# Access Compliance Report

## Public Rights-of-Way

Intersection ID: 53160	Main Street: PERTH_MOOR_RD	Cross Street: HAMILTON_BRIDGE_RD	Location: SW
ADA ID: C43D68DF350A	Ramp Type: Perp	Initial Pass/Fail: Fail	Overall Compliance: No
Severity Score: 21.25			
Codes/Mitigation Info/Possible Solution		Field Measurements/Component Compliance

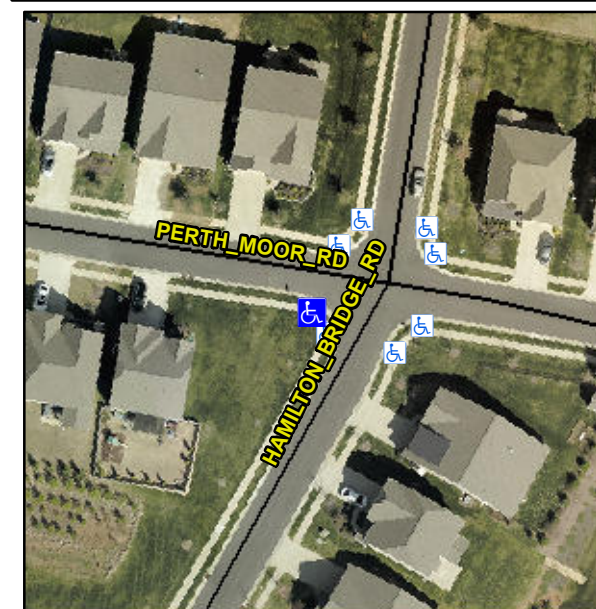
**R304.5.1, R304.2.2**

Compliance	Description	Data	Compliance	Description	Data
N/A	Ramp Length (in)	49.0	No	Ramp Slope (%)	8.8
No	Ramp Width (in)	46.0	Yes	Ramp XSlope (%)	0.8
N/A	Flare Type LT	N/A	N/A	Flare Type RT	N/A
N/A	Flare Slope LT (%)	N/A	N/A	Flare Slope RT (%)	N/A
N/A	Flare Traversable LT?	N/A	N/A	Flare Traversable RT?	N/A
N/A	Landing Length (in)	N/A	N/A	DWS Provided?	N/A
N/A	Landing Width (in)	N/A	N/A	DWS Contrast?	N/A
N/A	Landing Slope (%)	N/A	N/A	DWS Length (in)	N/A
N/A	Landing X Slope (%)	N/A	N/A	DWS Full Width?	N/A
N/A	Landing Curb? (Y/N)	N/A	N/A	DWS Offset (in)	N/A
N/A	Shared Landing?	N/A			
N/A	Gutter Ponding?	N/A	N/A	Gutter Slope (%)	N/A
N/A	Gutter Lip Ht (in)	2.0	N/A	Gutter X Slope (%)	N/A
N/A	Painted X Walk1?	No	N/A	Painted X Walk2?	N/A
	X Walk 1 Direction	To NE		X Walk 2 Direction	N/A
N/A	X Walk 1 Width (in)	N/A	N/A	X Walk 2 Width (in)	N/A
	X Walk 1 Slope (%)	4.4		X Walk 2 Slope (%)	N/A
	X Walk 1 X Slope (%)	0.2		X Walk 2 X Slope (%)	N/A

**Remove & Replace Entire Ramp.**
